Well Name: POKER LAKE UNIT 13-24 PC

Well Number: 707H

Type of Action: APD Change

Procedure Description: XTO Permian Operating, LLC. respectfully requests approval to make the following changes to the approved APD. Changes to include KOP, FTP, proposed total depth, pool, and dedicated acreage. FROM: TO: KOP: 2270' FNL & 1025' FEL OF SECTION 13-T24S-R29E 2636' FSL & 1031' FEL OF SECTION 13-T24S-R29E FTP: 1959' FNL & 1229' FEL OF SECTION 13-T24S-R29E 2504' FNL & 1027' FEL OF SECTION 13-T24S-R29E The proposed total depth is changing FROM 22021' MD; 9051' TVD TO 21980' MD; 8992' TVD. Pool code is changing FROM PIERCE CROSSING; BONE SPRING, EAST(96473) TO CEDAR CANYON; BONE SPRING(11520); PIERCE CROSSING; BONE SPRING(96473); WILDCAT S243006B; LWR BONE SPRING(97753) Dedicated acreage is changing FROM 719.94 ac TO 439.94 ac There is no new surface disturbance.

C-102 Sumbit electronically Via OCD Permitting	State of New Mexico Energy, Minerals & Natural Resources Department OIL CONVERSION DIVISION	Revised July, 09 2024
		Submittal Type: ☐ Initial Submittal ☒ Amended Report ☐ As Drilled

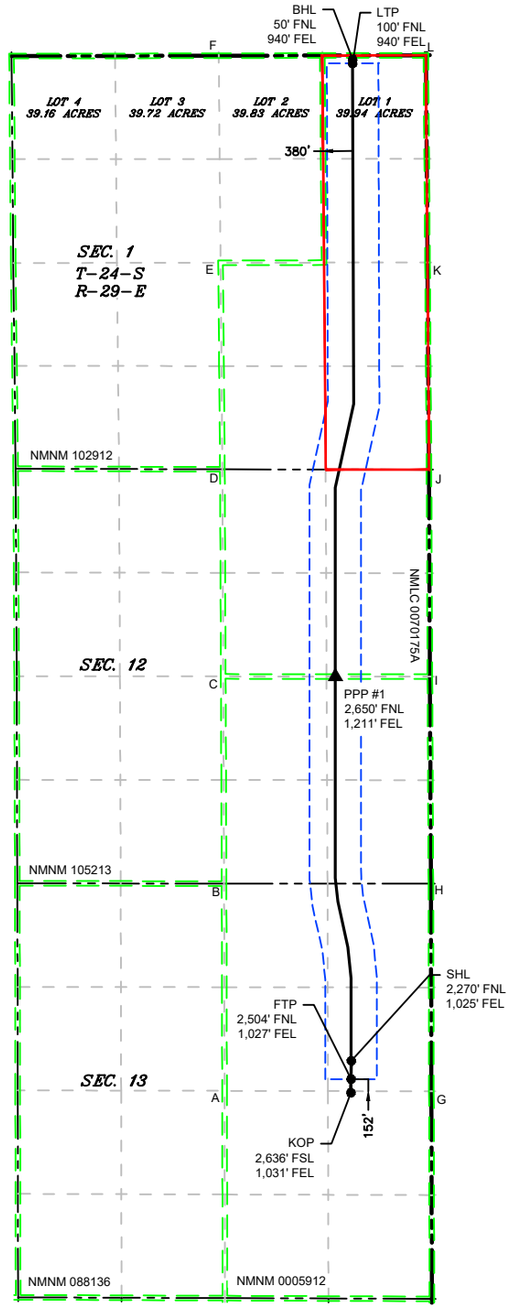
XTO Permian Operating, LLC. respectfully requests approval to make the following changes to the approved APD. Changes to include KOP, FTP, proposed total depth, pool, and dedicated acreage.

FROM: TO:
KOP: 2270' FNL & 1025 FEL OF SECTION 13-T24S-R29E 2636' FSL & 1031 FEL OF SECTION 13-T24S-R29E
FTP: 1959' FNL & 1229' FEL OF SECTION 13-T24S-R29E 2504' FNL & 1027' FEL OF SECTION 13-T24S-R29E

The proposed total depth is changing FROM 22021 MD; 9051 TVD TO 21980 MD; 8992 TVD.

Pool code is changing FROM PIERCE CROSSING; BONE SPRING, EAST(96473) TO CEDAR CANYON; BONE SPRING(11520); PIERCE CROSSING; BONE SPRING(96473); WILDCAT S243006B; LWR BONE SPRING(97753)

Dedicated acreage is changing FROM 719.94 ac TO 439.94 ac
